**REPORTS OF GEOLOGICAL SURVEY
FOR
CIVIL ENGINEERING WORKS**

Reports of Geological Survey for Civil Engineering Works compiled by Kazuji Uno, Expert on Engineering Geologist dispatched by the Japan International Cooperation Agency (JICA) to the Republic of Indonesia under the Colombo Plan Technical Cooperation Scheme (dispatched duration: from July 1974 through July 1980).

NOTES ON THE GEOLOGIC - SOIL MECHANIC REPORT OF
INDRAPURA PROJECT, WEST SUMATRA

COMMENT ON THE REPORT OF GEOLOGICAL AND SOIL MECHANIC SURVEY OF CLOSING DAM OF AIR SELUMA PROJECT, BENGKULU PROVINCE. (FINAL REPORT, JUNE 1978, CV TRIDJAYA).

Fig. 4 Cross Section & Plan of Closing Dike

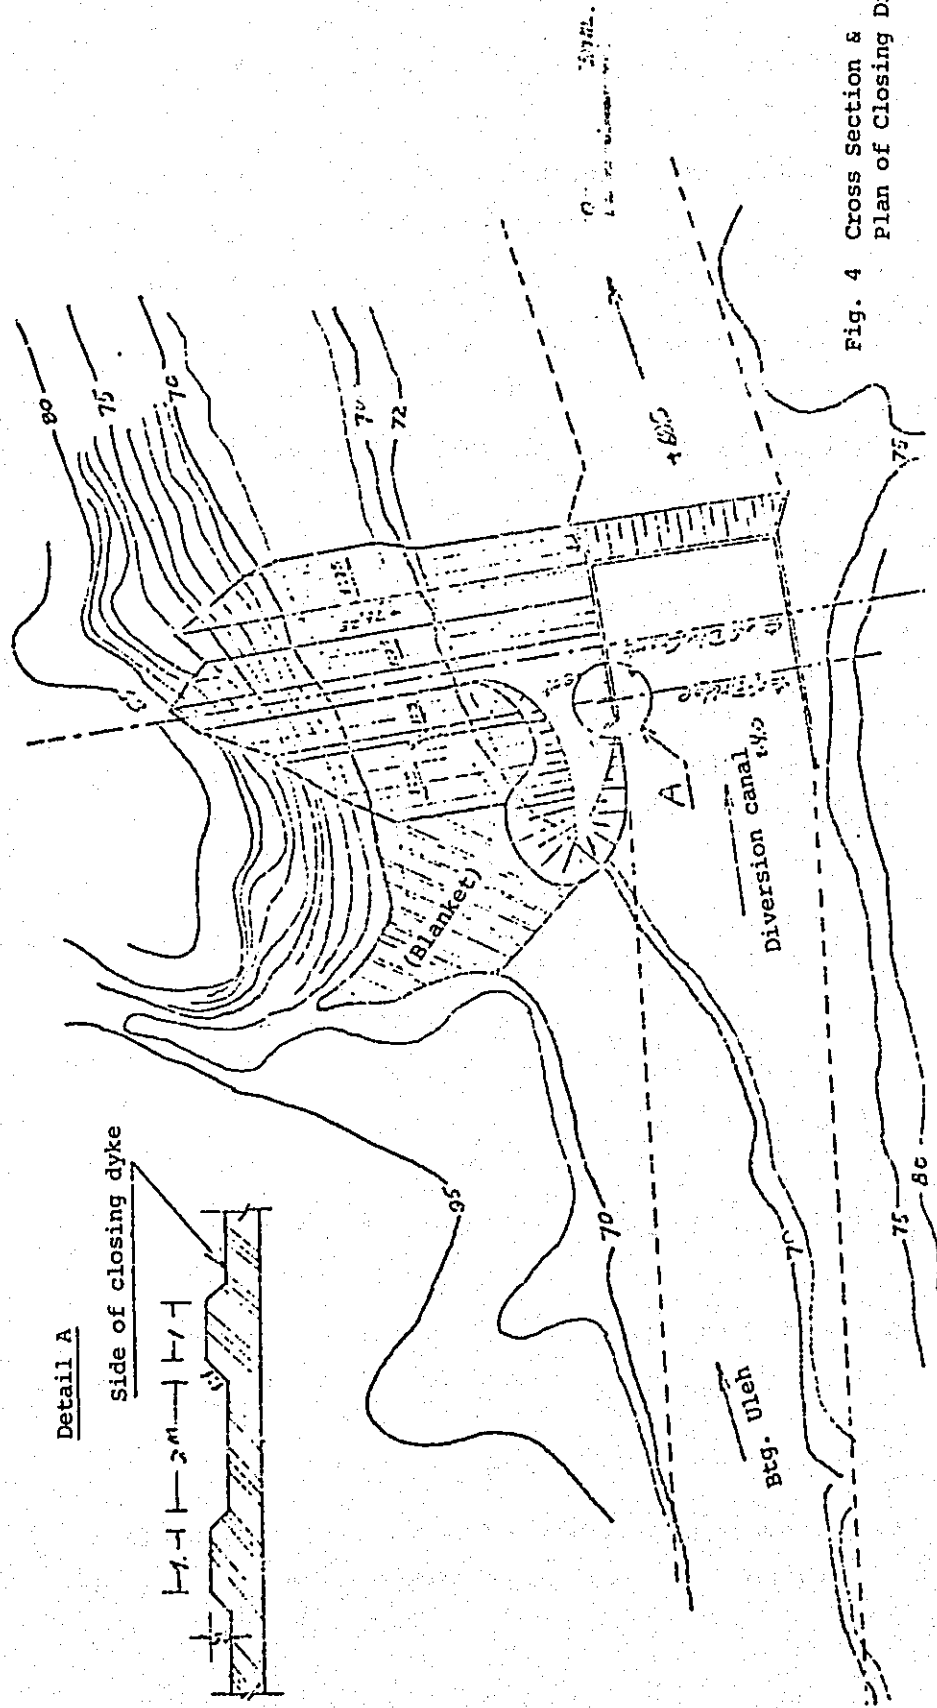
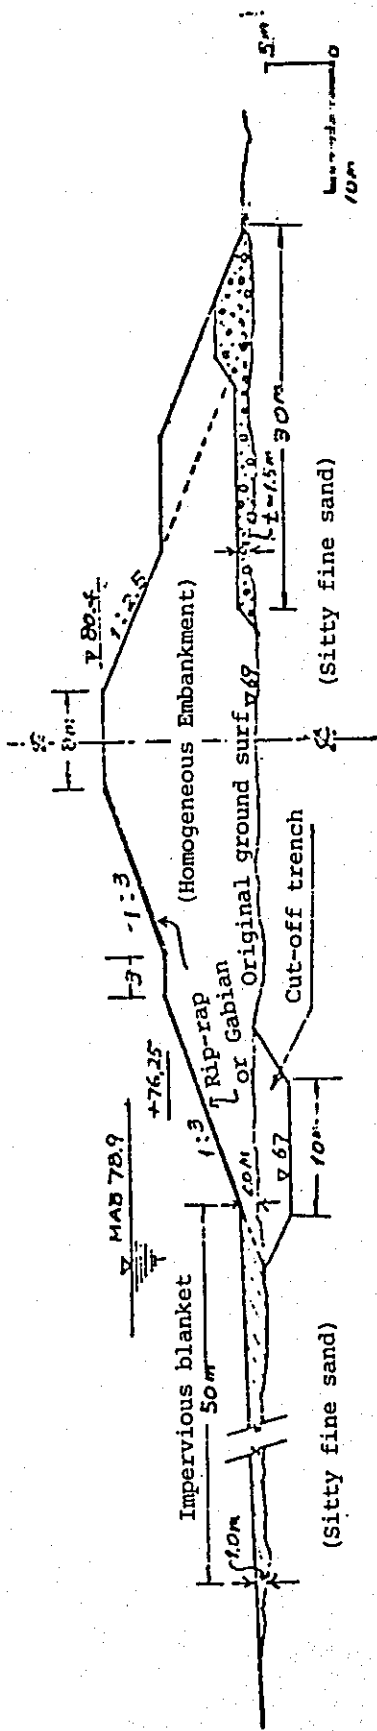
Based upon studies or discussion stated in the previous sections, a basic design of embankment, ie., standard cross section and plan of the closing dike is proposed in Fig. 4.

Total embankment volume is tentatively estimated approximate 50 thousand cu. m including blanket based upon Fig. 4, the plan of which is too small to precisely estimate volume required for the closing dike.

Fig. 5 Sketch of Cracks and its Treatment

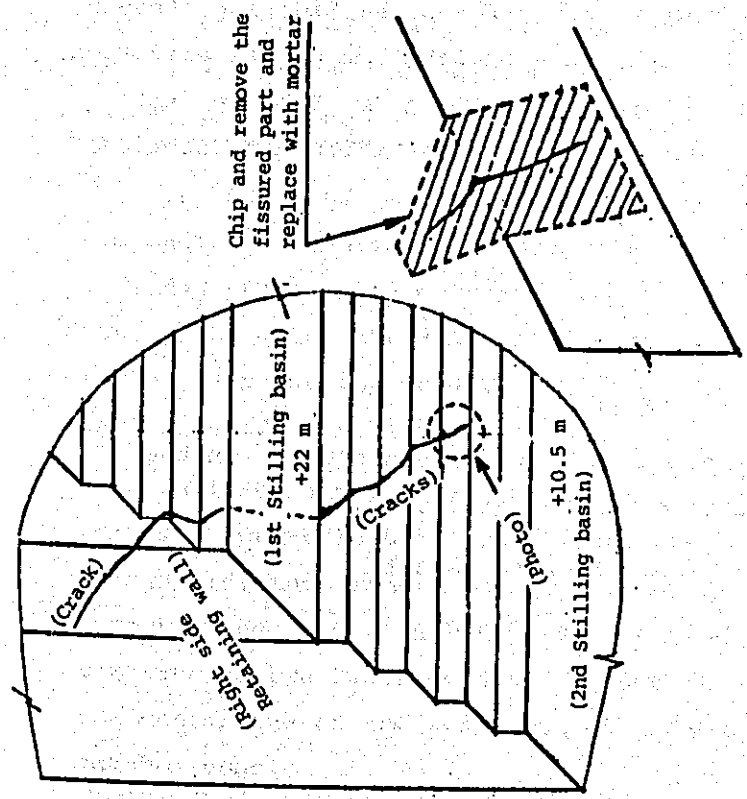
Judging from such situation, it may be possible for treatment to use ordinal way which has been applied for the fault treatment of dam foundation. That is, concrete plug and grouting are usually adopted for the fault larger than several ten cm in width. For small fault as found in this case, it is usually to remove the fractured or softened zone in the both sides of crack and to place wedge of mortar or concrete as deep as possible. (See Fig. 5)

Fig. 7 Grouting

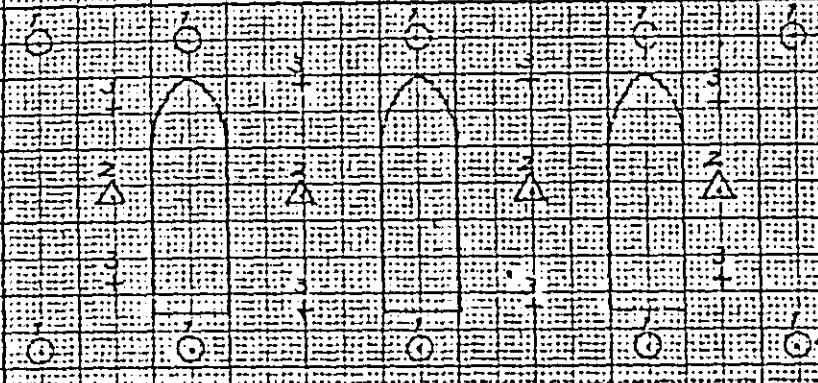
- (3) The disposition of grout holes can be considered by several way. One example is shown in Fig. 7 (a). Groutings are operated in order from 1st group and, 2nd group and so on and injected at their middle point between previous ones. The grouting pattern may be modified sometime from the result of grouting.
